REGIONAL REVIEW FINDING

ARC REVIEW CODE: R1407141

Name of Proposal: Shannon Mall Redevelopment

SHANNON MALL REDEVELOPMENT DRI
City of Union City, Fulton County
Natural Resources Division Review Comments
July 10, 2014

CONCEPT PLAN

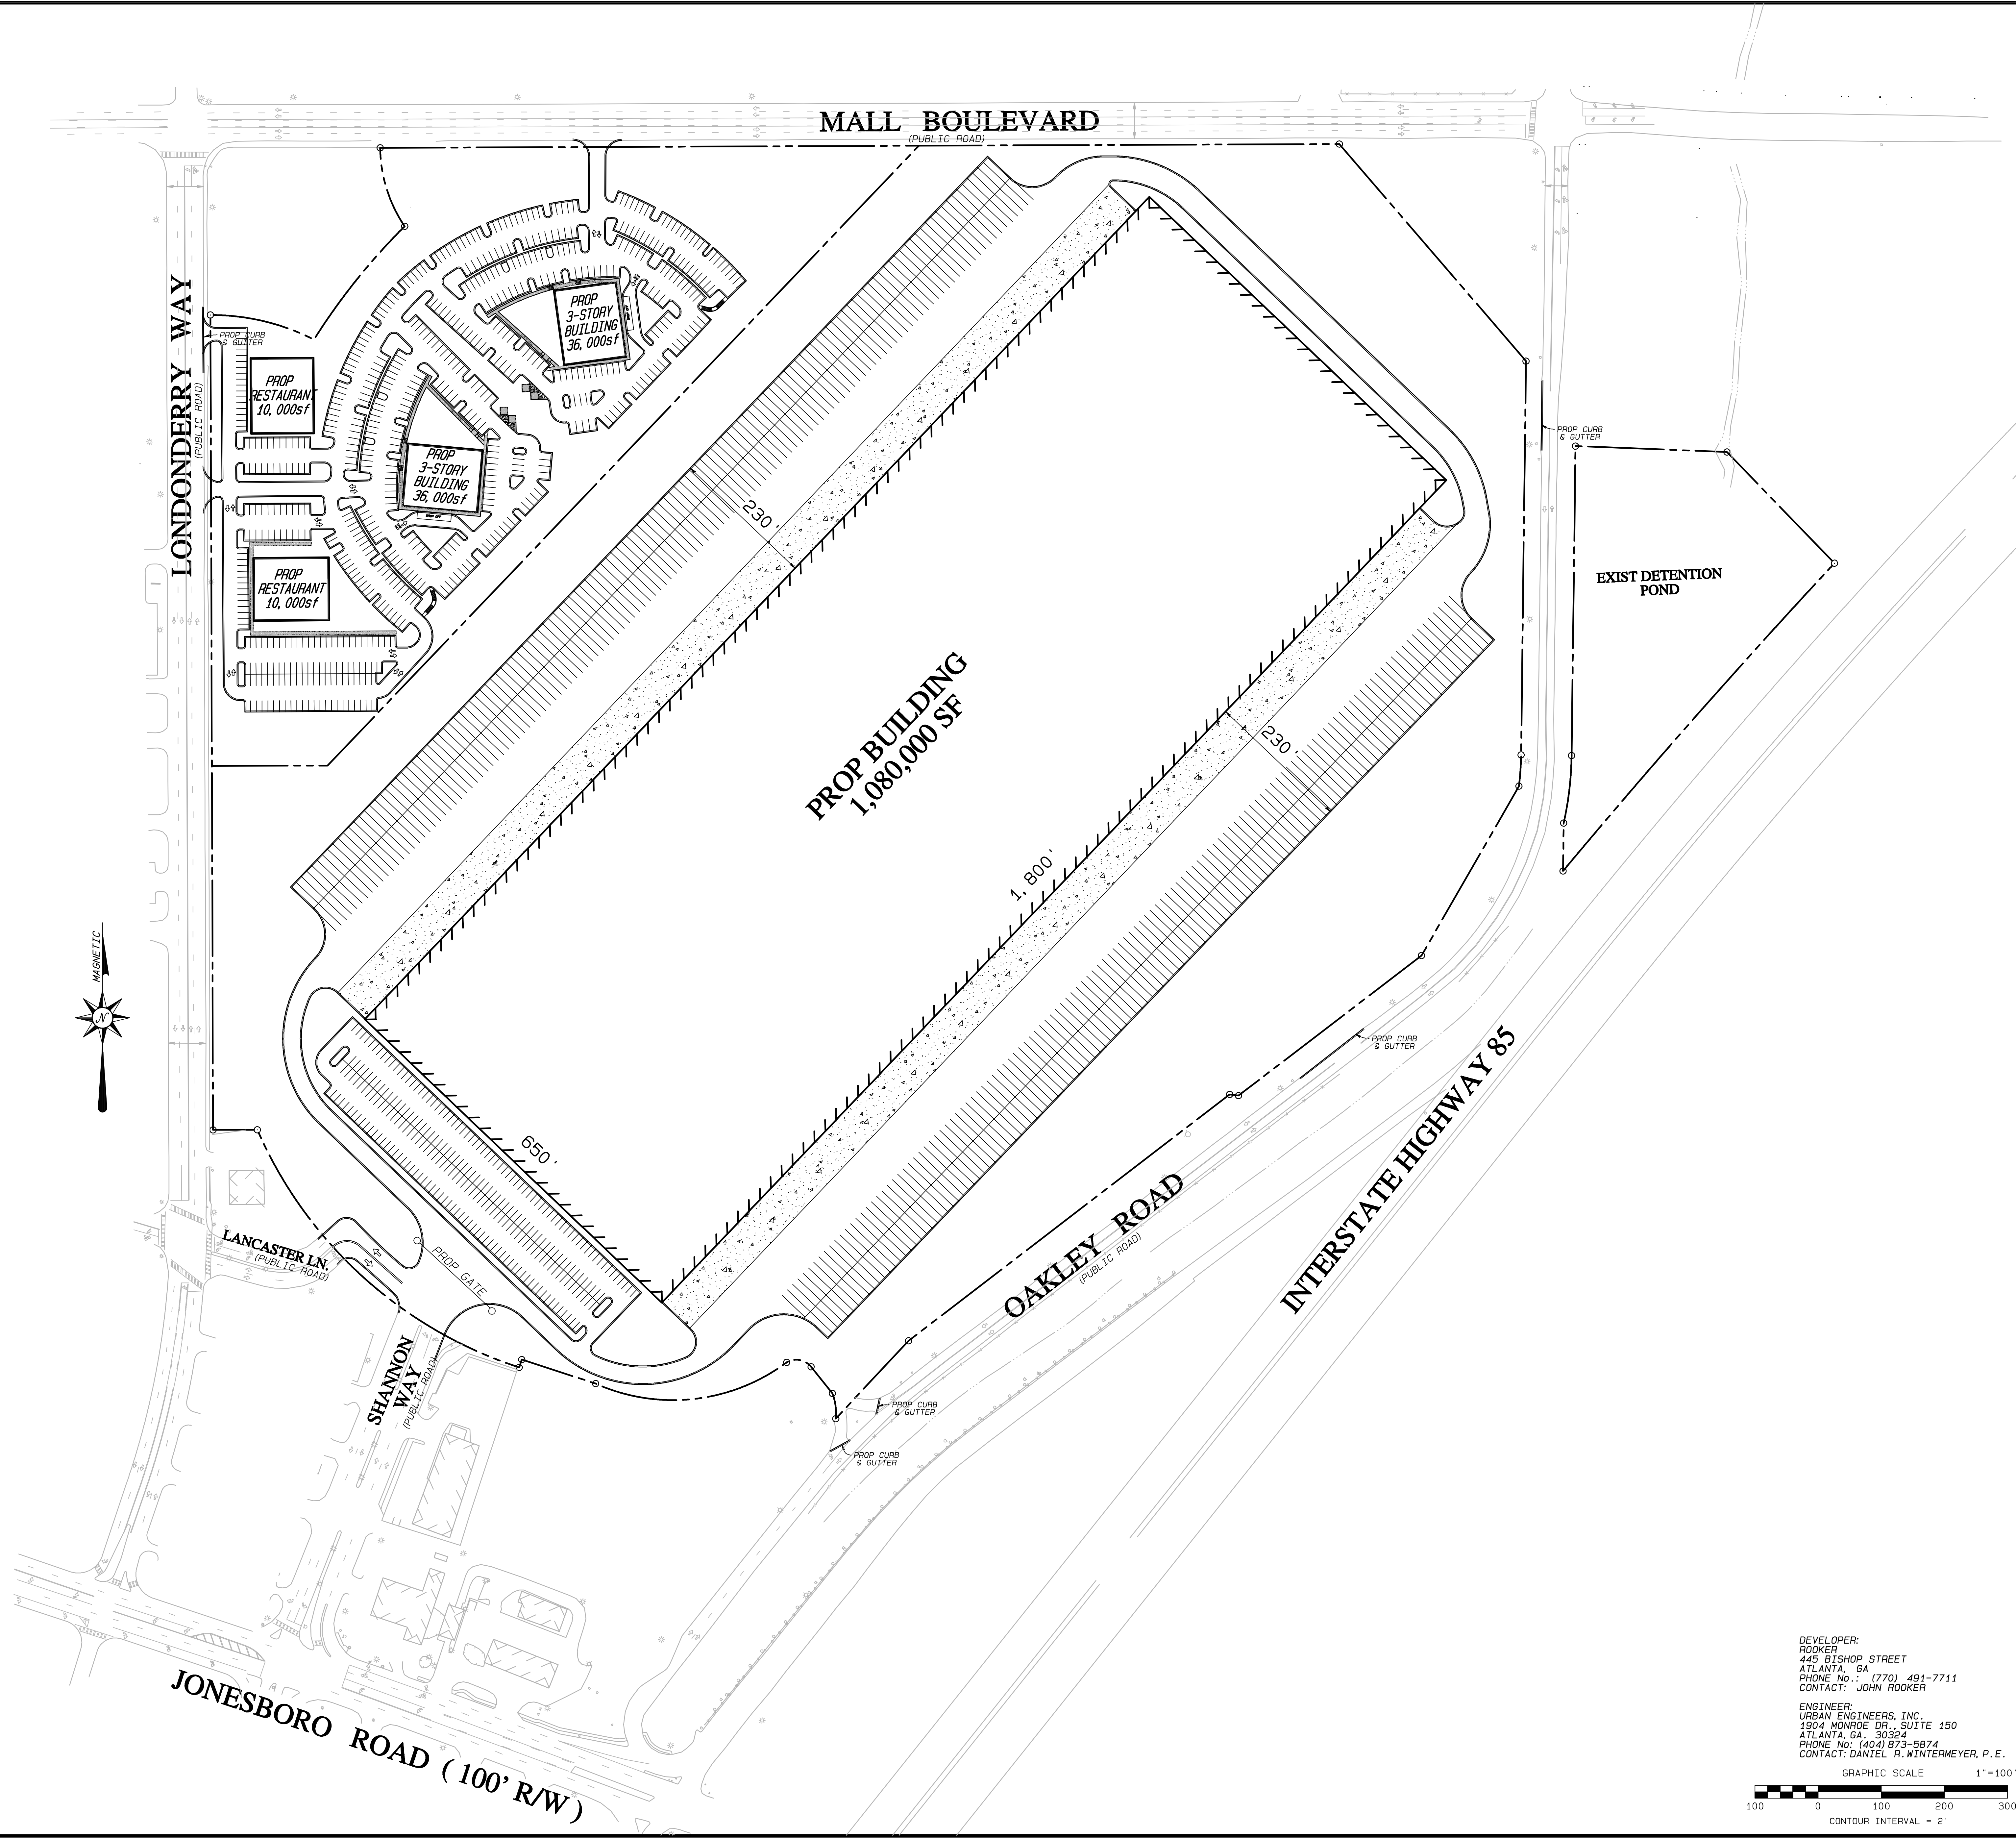
A blue-line tributary to Morning Creek crosses the detention pond parcel located to the east of the main parcel and between Oakley Road and I-85, as shown on the USGS coverage for the project area. Any work in this portion of the property will be subject to the requirements of the Union City Stream Buffer Ordinance. Any unmapped streams that may be on the property may also be subject to the requirements of the City stream buffer ordinance if they meet ordinance criteria. Any state waters that may be on the property are subject to the State 25-foot erosion and sedimentation buffer requirements.
